ISSUE RESOLUTION STATUS REPORT

**KEY TECHNICAL ISSUE:
STRUCTURAL DEFORMATION AND SEISMICITY**

**Division of Waste Management
Office of Nuclear Material Safety and Safeguards
U. S. Nuclear Regulatory Commission**

SEPTEMBER 1998

Figure 3 - Tramuv model-well miss-tie analysis plot illustrating the difference between the computed horizon and the picked well-log elevations using color coded contours

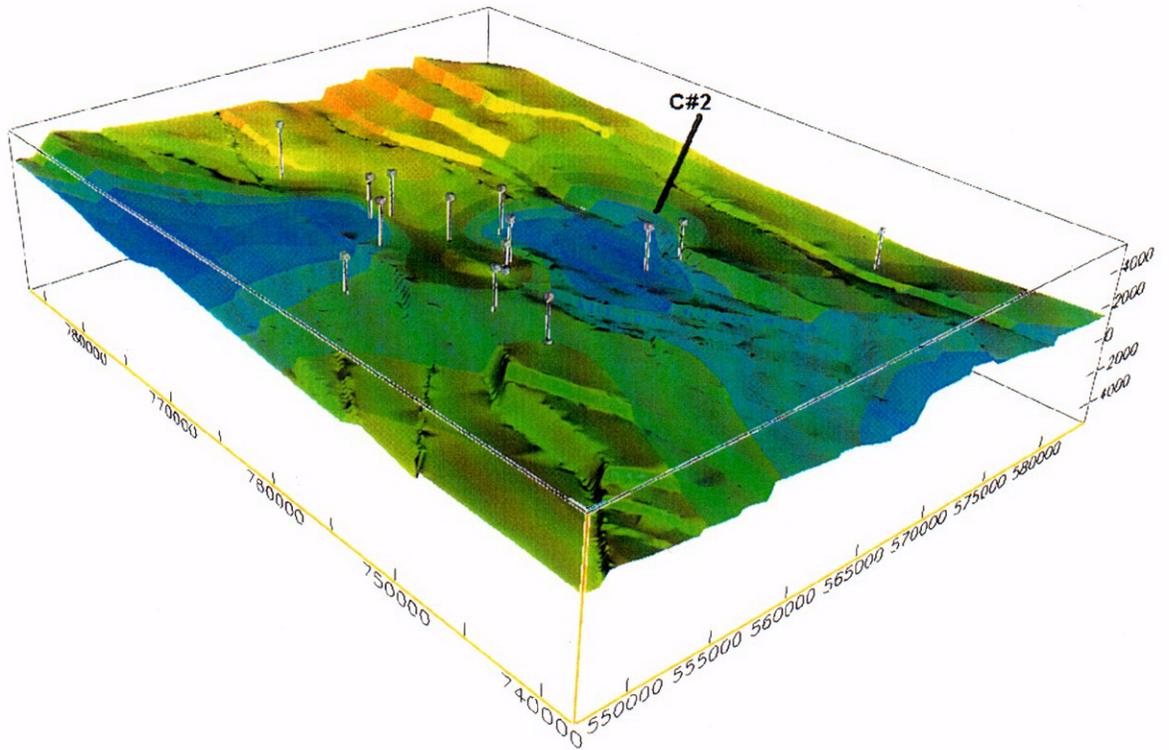
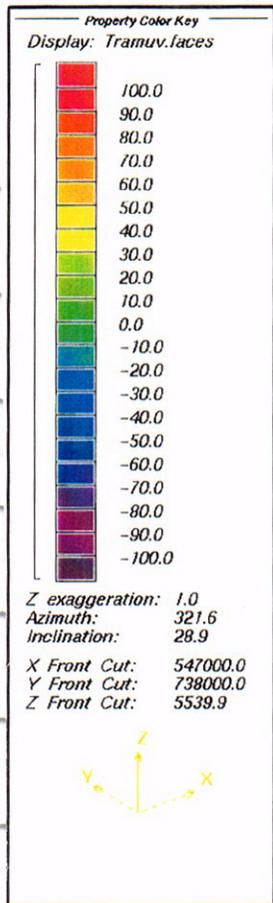
Figure 3 contains a 3-D view of the upper vitrified Tram unit with the model-well discrepancies plotted as color-filled contours. The legend on the left side of the plot defines the miss-tie range as plus/minus 100 feet. The gray boxes above the model surface represent the locations of the well log data that were used as control points for computing the horizon elevations. The red circular region in the vicinity of the C#2 well represents a model-well mismatch of -53 feet. This means the EarthVision software computed the elevation of the horizon to be 53 feet higher than the geologist picked the horizon location on the C#2 well logs. Only 14 well control points were available for the computation of this Tram unit, and Figure 3 illustrates that the C#2 well is not surrounded by wells having smaller model-well miss-ties. Thus, one cannot confidently say that the C#2 well log pick is bad and has been disregarded by the EarthVision software as an outlier. A case could be made that: (1) the -53 foot C#2 discrepancy is the result of insufficient data to constrain the EarthVision software; or (2) that the fault structure in the GFM3.0 model has resulted in the C#2 well being located on the wrong side of a fault. Figure 3 shows the C#2 well in very close proximity to the Midway fault, which may possibly be explained by an incorrect assumption that: (1) the C#2 well is not deviated; or (2) that the subsurface control on the Midway fault is incorrect.

Figure 4 - Calico model-well miss-tie analysis plot illustrating the difference between the computed horizon and the picked well-log elevations using color coded contours

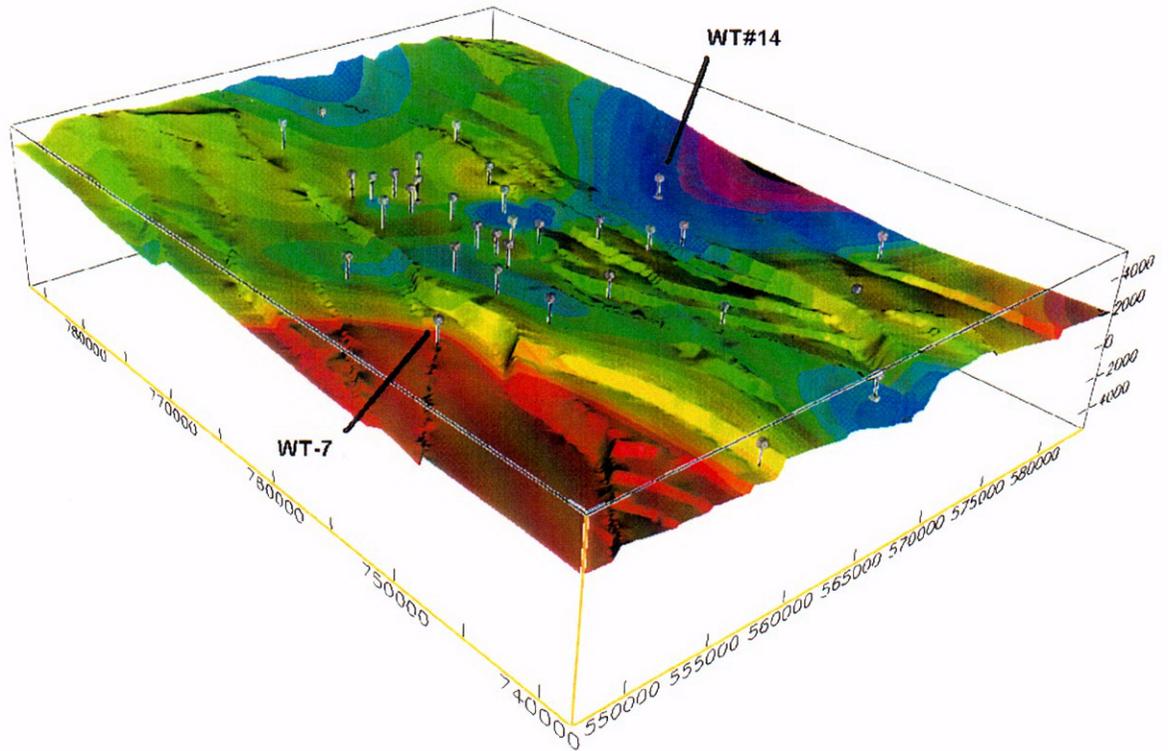
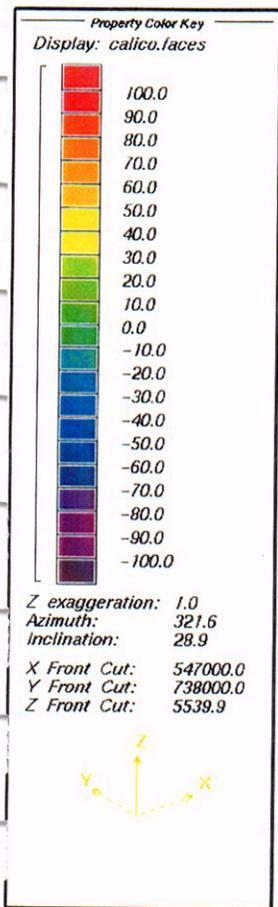
Figure 4 shows discrepancies of +117 and -56 feet where the WT-7 and WT#14 wells intersect the Calico horizon near the SolWest and Paintbrush faults, respectively. Figure 5 also shows +59 and -88 foot discrepancies for the WT-7 and WT#14 wells intersecting the Tptpl unit. Again, it may be possible to ascribe the discrepancies to incorrect borehole placement or inaccurate subsurface fault control. However, the -117 foot discrepancy for the WT#6 well in Figure 5 is not as easily explained because a fault surface is not present in the vicinity of the borehole. This disagreement may possibly be explained as a data outlier, poorly constrained software calculations, or the presence of an unmapped fault.

Figure 6. Fault Ironw3 (tan) modified to intersect the Solitario Canyon fault (green) no deeper than -2000 feet. Original Splay S is also shown

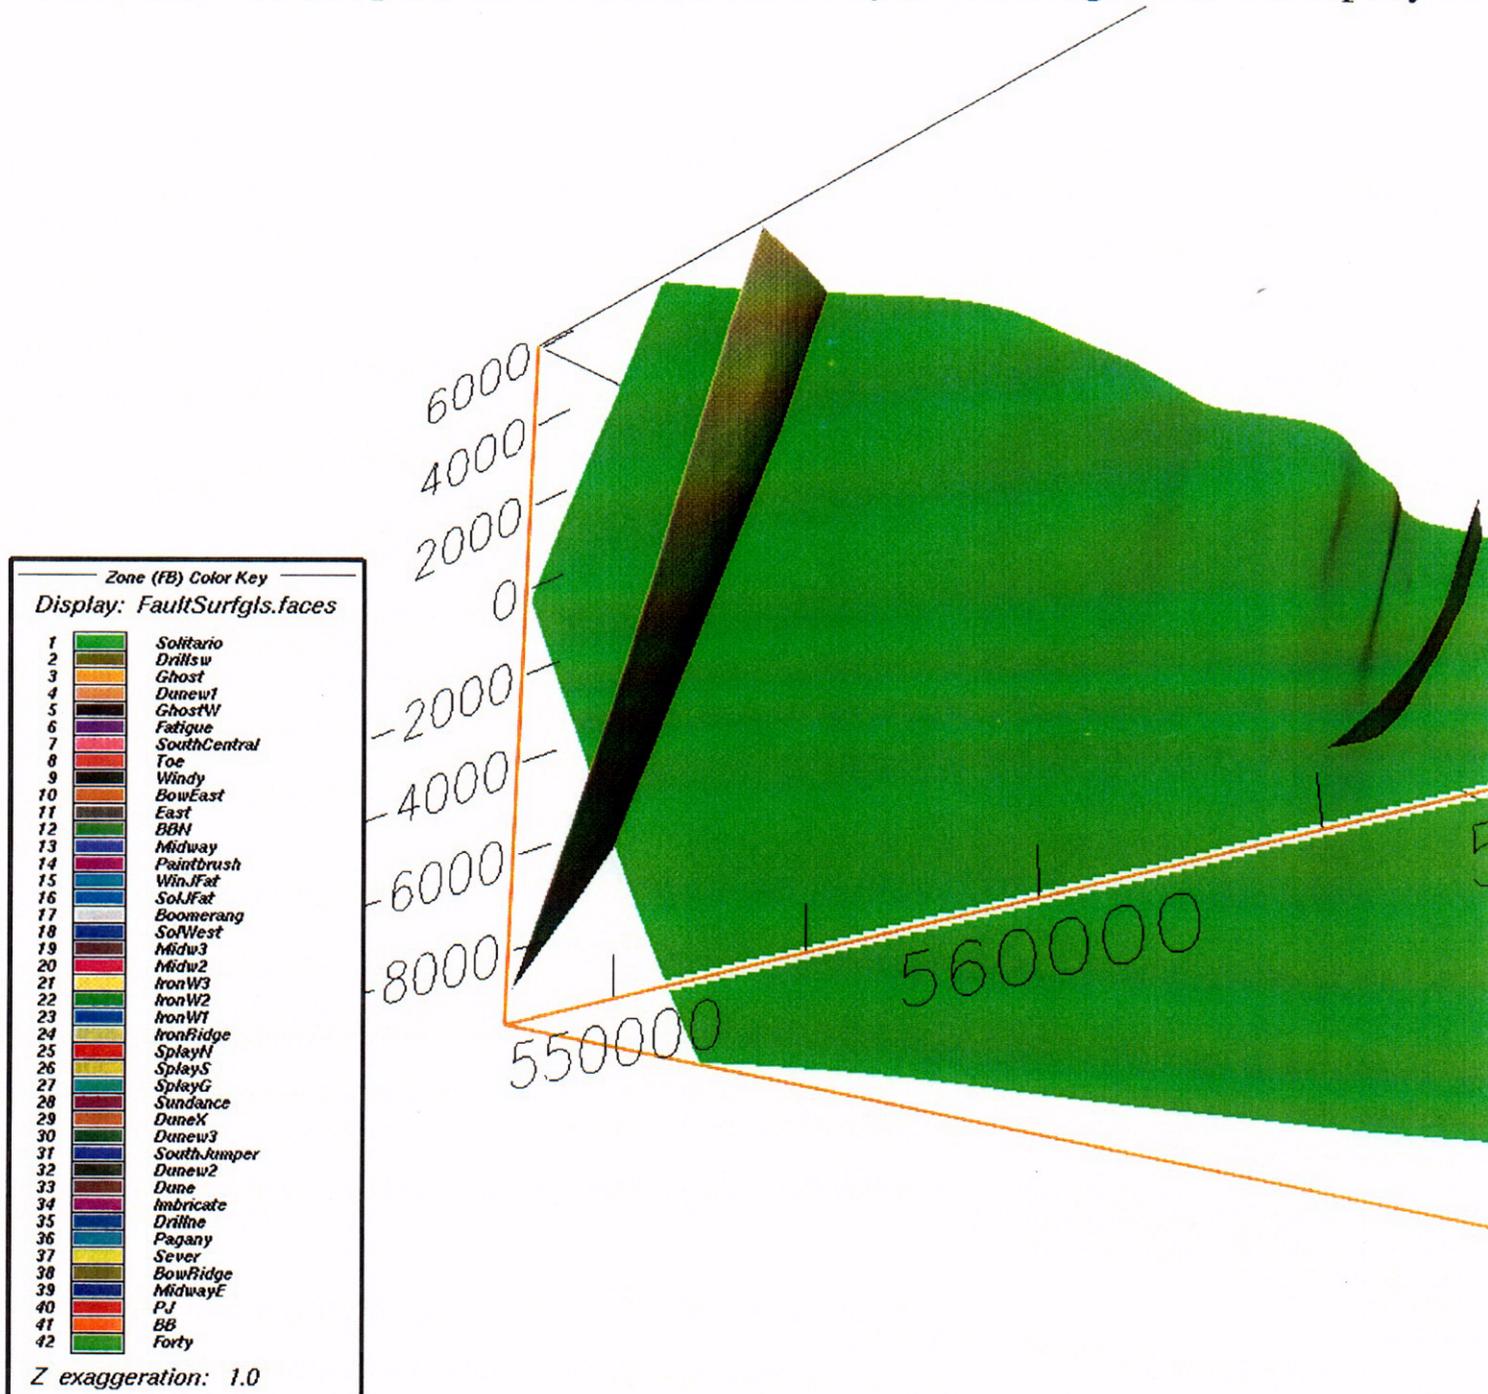
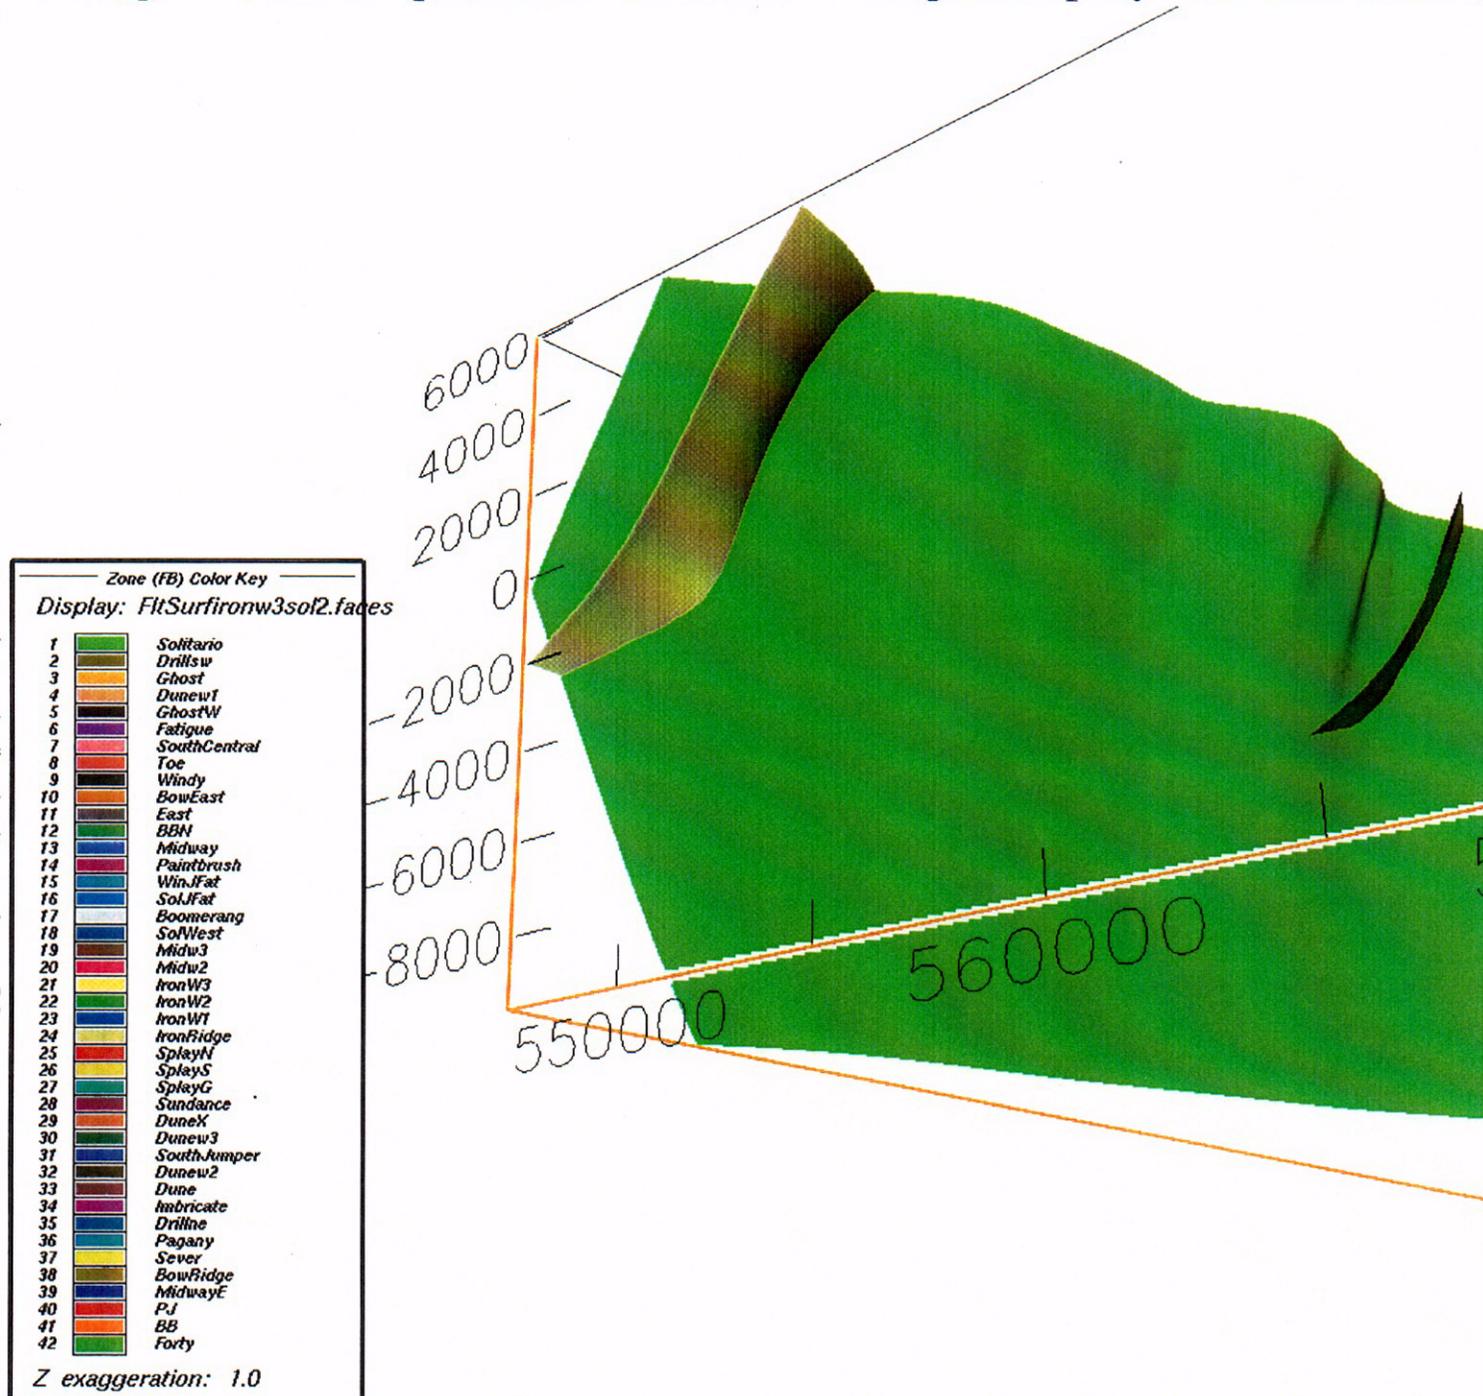
Faults Ironw1, Ironw2, and Ironw3, located in the southwestern corner of GFM3.0, were represented in the model as planar structures extending to the base of the model at -8000 feet. The subsurface geometry of fault Ironw3 in the "Ironw" system was successfully modified to generate a non-planar fault that terminated at a depth no greater than -2000 feet against the Solitario Canyon fault. This test illustrates that it is practicable to alter subsurface geometry of faults in GFM3.0 for incorporating alternative interpretations of fault geometry. Figure 5 illustrates the planar subsurface geometry of Ironw3 as originally represented in GFM3.0 along with non-planar fault Splay S. Figure 6 shows Ironw3 as modified for this test to terminate against the Solitario Canyon fault at a depth no greater than -2000 feet. Fault Splay S is included in the figure to show the similarity between the geometry of Splay S and modified Ironw3.

In summary, the result of this successful test illustrated by Figure 6 proves it is possible to modify GFM3.0 and incorporate alternative interpretations of subsurface fault geometry into the model. Although a detailed explanation of the steps necessary to generate modified fault surfaces is beyond the scope of this letter report, some words of caution are advised. When fault geometries are changed, before running the master sequence (.seq) file in GSB to generate modified .faces files for structure models, it may be necessary to rebuild the fault tree or re-grid horizons in the fault blocks. In particular, if the number of fault blocks is either reduced or increased, as is likely when removing an existing fault or adding a new one in the model, rebuilding the fault tree and re-gridding of horizons in the altered fault blocks are commonly necessary before the .seq file can be used in GSB to calculate .faces files for the suite of structure models (i.e., fault surfaces and blocks and zone surfaces and blocks).

Figure 8 – Cross section 1. This section illustrates folding in the hangingwall of the PCF without curvature in the associated fault plane. Slight curvature of the FMWF may not be sufficient to produce tilting as shown in the hangingwall. See Figure 7 for location.

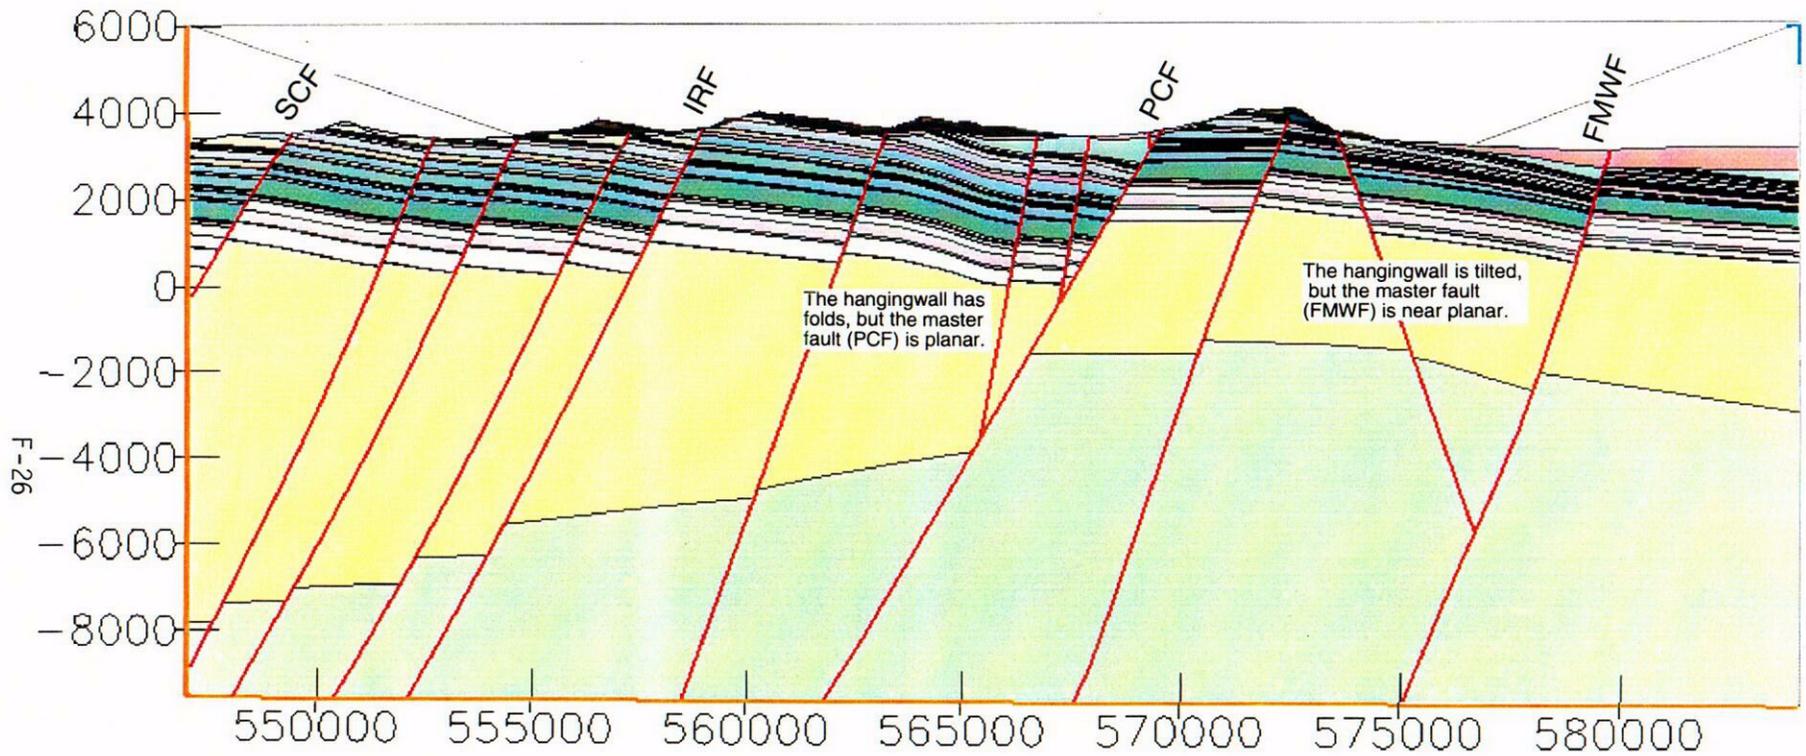
- d. Folding developed in the hangingwall blocks of faults is generally attributed to a curved (i.e., listric) fault geometry at depth (Suppe, 1983; Dula, 1992). Sections 1 (Figure 8) and 8 (Figure 15) through the model appear to illustrate folding of units in hangingwall blocks although GFM3.0 is constructed with essentially planar faults. Explanation of why these units appear to be folded may be helpful. By some interpretations (e.g., Young, et al., 1992), at the depth to which the model was constructed (i.e., 8,000 feet below sea level), the Forty Mile Wash, Paintbrush Canyon, Midway Valley, and Bow Ridge faults would show curved trajectories.

Figure 10 – Cross section 3 illustrates complex fault geometries, including fault displacement decreasing with depth (SCF), faults that are terminated updip by other faults, and crossing fault geometries. See Figure 7 for location.

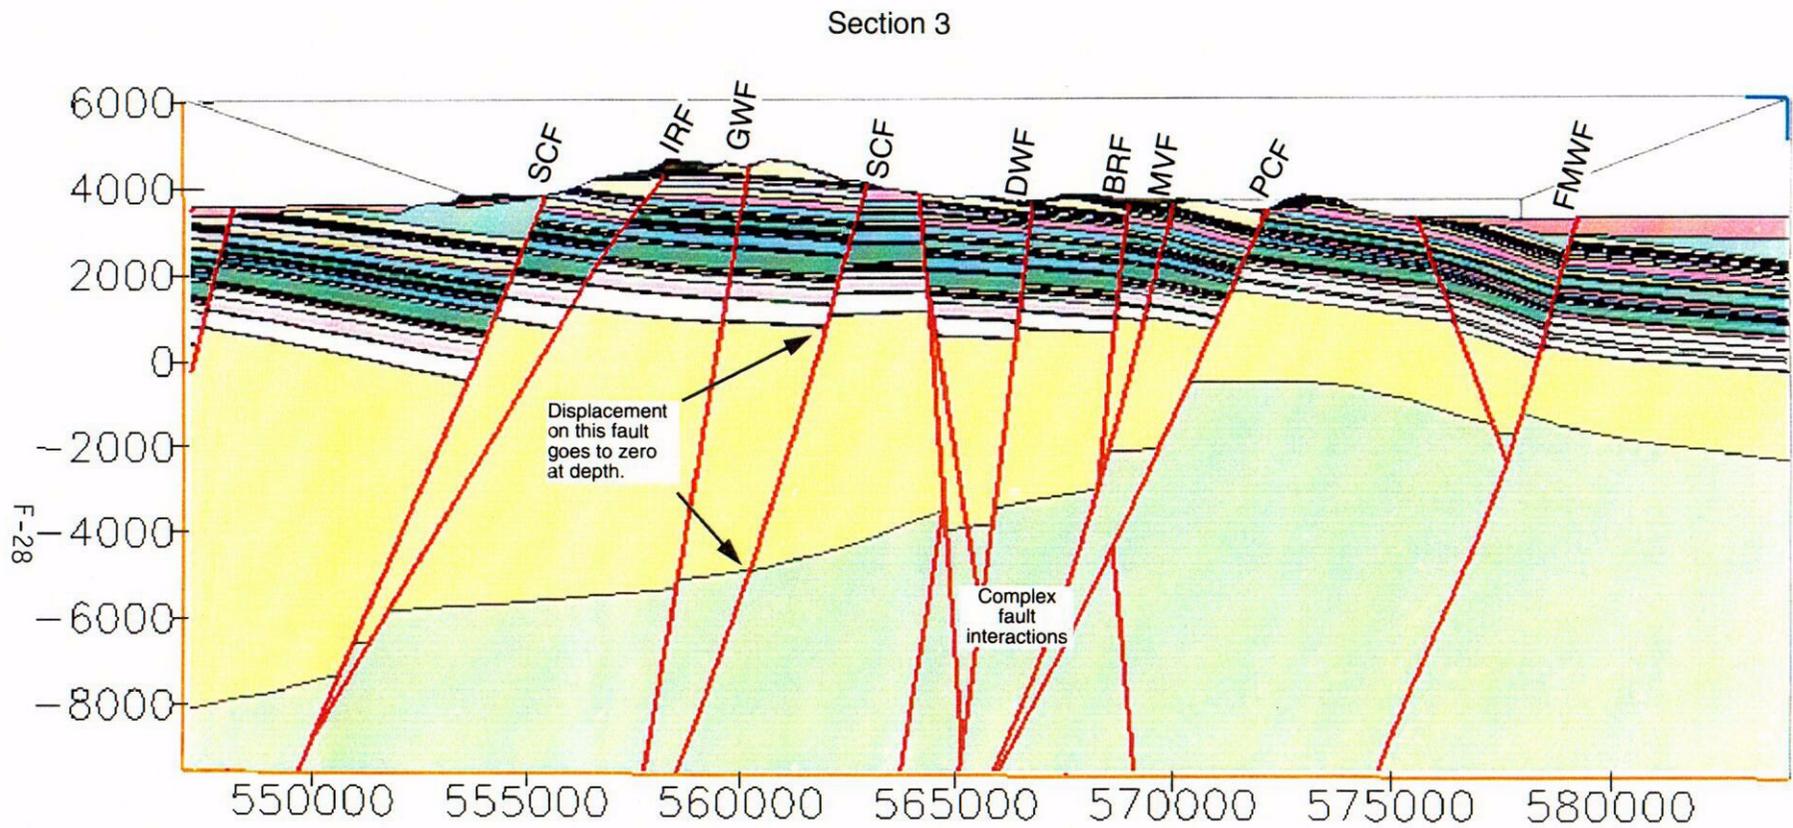
- h. Complex interactions between faults with opposing dip (e.g., Section 3, Figure 10) are likely in the Yucca Mountain area (Brocher, et al. 1998) and may be important influences on groundwater flow (Ferrill, et al. 1998). Variable displacement values between different units at the same position along a given fault and beheaded faults without a continuation across the offsetting fault are examples of complex fault interactions. Consider clarifying whether these complex interactions are real or modeling artifacts.
